Industry proposal about “Minimal risk manoeuvre”

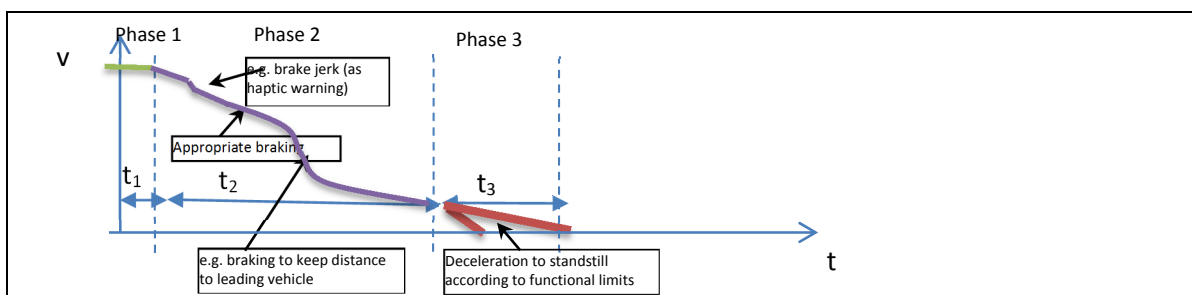
- 2.4.8.14 "Minimal risk manoeuvre" means a procedure aimed at reducing risks in traffic, which is automatically performed by the system when the driver does not respond to a transition demand (e.g. by reducing vehicle speed).
- 5.6.1.5.1. If the ACSF detects that after a transition demand the driver does not take over manual control of the steering again the vehicle shall carry out a minimal risk manoeuvre. The vehicle manufacturer shall provide information to the technical service about which kind of minimum risk manoeuvres are foreseen depending on the given traffic situation.
- 5.6.1.5.2. It shall at any time be possible to override the minimal risk manoeuvre by the driver
- [5.6.1.5.3. During the minimal risk manoeuvre, the available assistance functions like Advanced Emergency Braking System shall remain operational.]
